**DEPARTMENT OF TRANSPORTATION
STATE OF GEORGIA**

SUBJECT PROJECT CONCEPT REPORT APPROVAL

Lilburn Connecting Sidewalks Project
GaDOT Project Number: STP-0004-00(457)
P.I. Number: 0004457, Gwinnett County

RE: Project Concept Report
Lilburn Road Sidewalks
GaDOT Project No. STP-0004-00 (457), PI No. 000457, Gwinnett County

TYPICAL SECTIONS

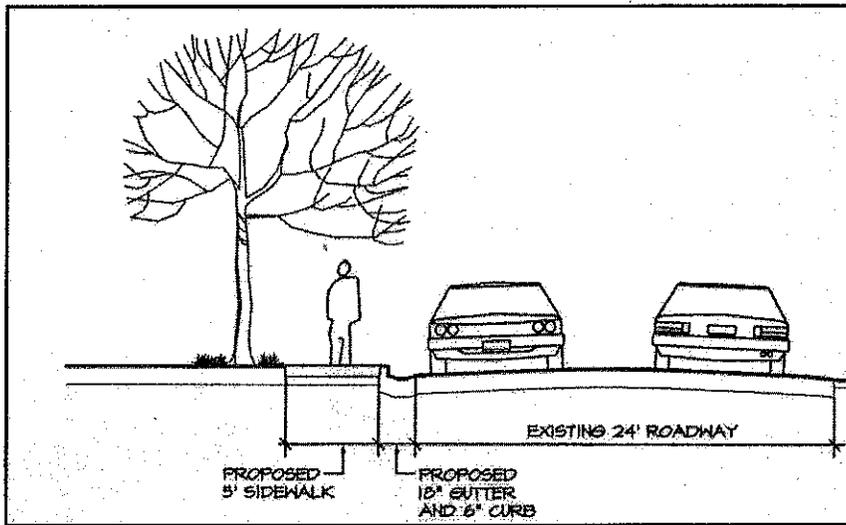
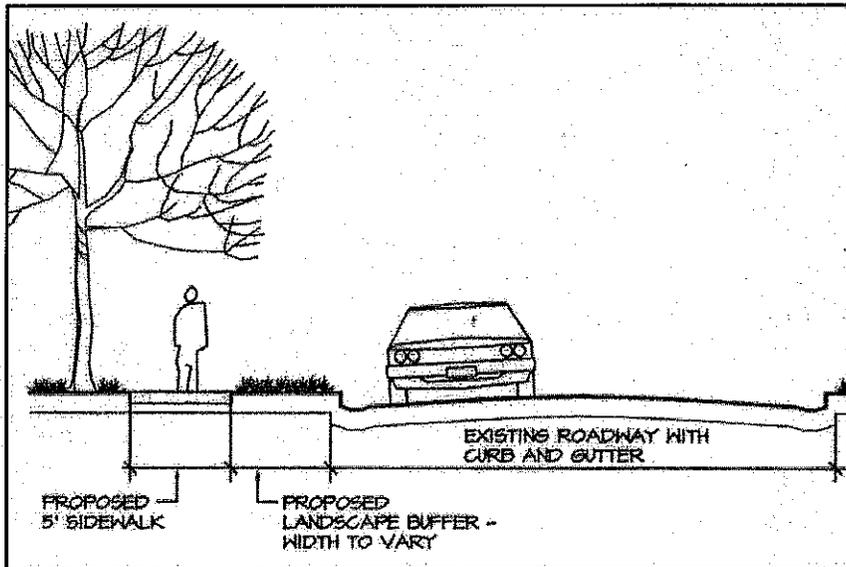
6. Typical section shows trees placed just behind the five foot sidewalk with no beauty strip. Is consideration being give to sight distance, obstruction of signs, signals and street lights?

- 6) Obviously we are required to adhere to GDOT design standards. Sight distances will be considered and requirements adhered to. This comment is covered in existing concept.
